# HARTING Product Change Notification

**PCN/21/007/C+N/US**

**Title:** Change to InduCom Hoods

Date: 04/12/2021

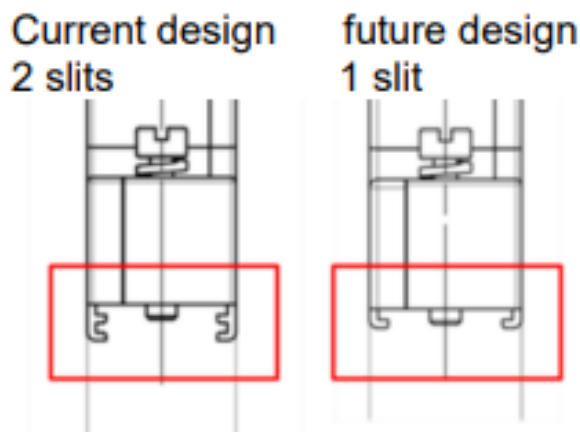
At the end of 2019 HARTING changed the design of the Inducom hoods. At the outer side of the hoods a 2nd slit was added (see picture below). This slit was intended for use with a mechanical coding option to be launched in the future. Please be informed, that HARTING will eliminate this 2nd slit. With this change the overall length of the hoods will be reduced to the same dimension as the pre-2019 design

When the new coding system is introduced we will create separate part numbers for the corresponding hoods with two slits.
